Proposed amendment to Auckland CTR

– airspace user consultation

Figure 2 – ‘Training Track’

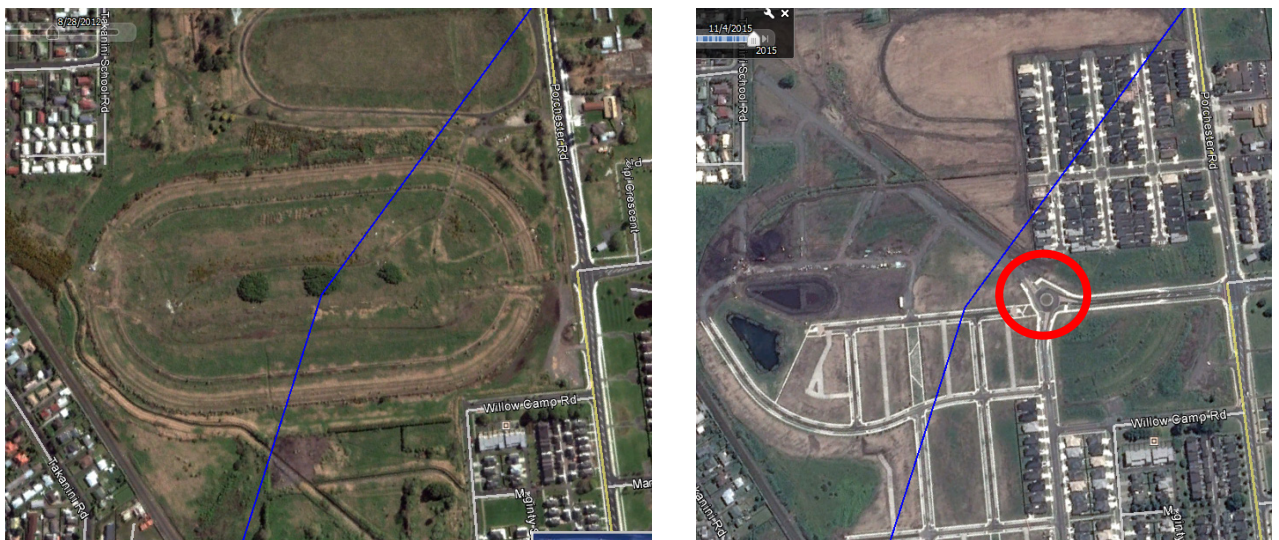
However, there is one amendment to the planned boundary change necessary as the previously used point feature no longer exists. The previous boundary line which goes from existing Alfriston (remains the same) boundary point following a straight line to ‘Training Track’ to Karaka VRP (this boundary point changes – existing VRP remains).

The ‘Training Track’ has now been closed and a housing subdivision has been built there. Refer to Figure 2 below. The blue line is the current CTR boundary. The photo on the left is from 2012 and the one on the right from 2015.

The choice is to either use the existing coordinate with no descriptor, or to make a small adjustment to overhead the roundabout (circled in red) would allow for an easily identifiable boundary point.
